SERVICE DIRECTIVE BULLETIN NO. 0017

REVISION C

SUBJECT: Revised Transmission Overhaul Life

MODEL: F-28A/280 Reference AD-74-05-03 and SDB 0017B

FIG. 1

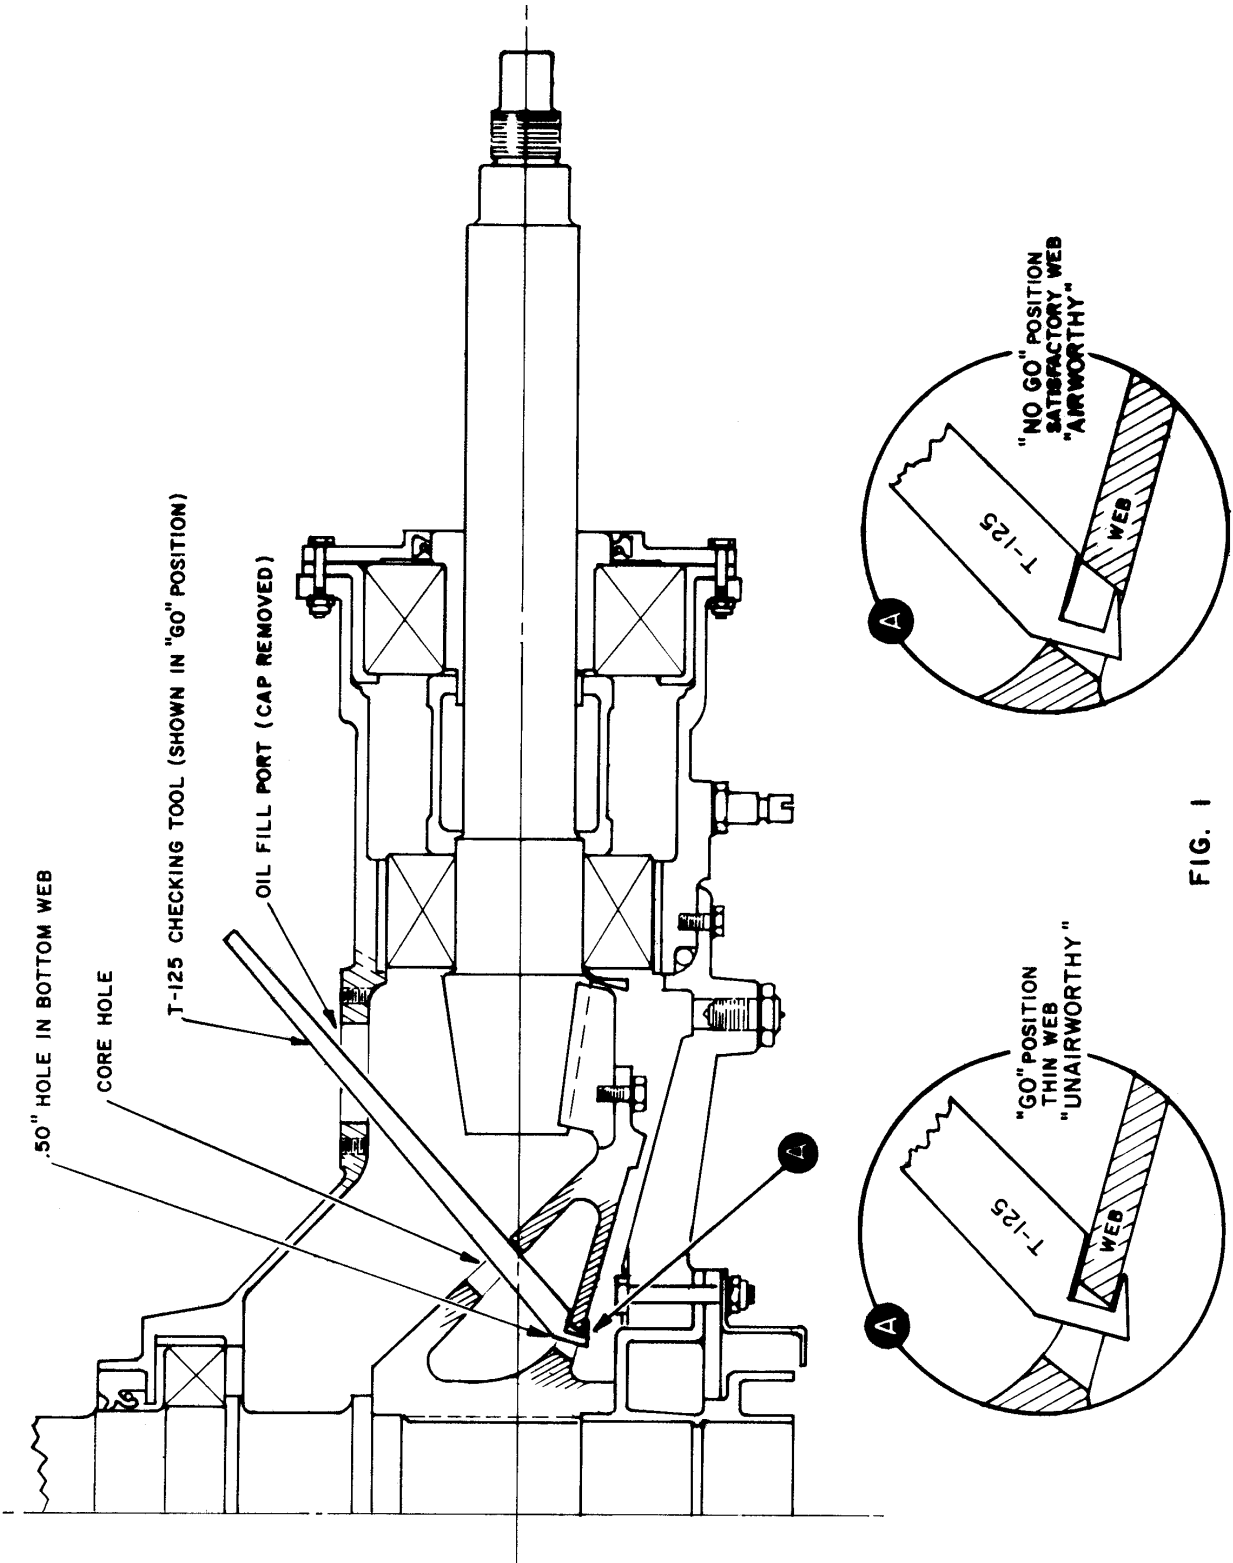
A “go - no go” gauge (P/N T-0125) is provided with this bulletin to aid maintenance personnel in conducting this inspection. By looking through the oil filler port and rotating the main rotor shaft until the core hole in the webbed outer surface of the carrier is in alignment with the filler port, the inspector can observe the lower inside surface of the ring gear carrier visually. (Ref. Figure 1.) Inspection for the following conditions must be made:

- (A) If no hole is observed on the lower inside web of the carrier in line with the core hole, the carrier is airworthy and can go the full established overhaul limit.
- (B) If a .50 inch diameter hole is observed in line with the core hole, the lower web thickness of the carrier must be checked with the go - no go gauge as indicated in Figure 1. If the gauge will not go on the lower web, it is airworthy and can go the full established overhaul limit.
- (C) If a .50 inch diameter hole is observed in line with the core hole, and the gauge slips over the lower web, the carrier is unairworthy and must be retired from service.

- NOTES:
- 1. The carriers must be checked through all three core holes. If the checking tool slips over the web in any location, the carrier is unairworthy.
  - 2. In order to provide sufficient lead time to procure replacement parts, please notify Enstrom Helicopter Service via the attached prepaid postcard.
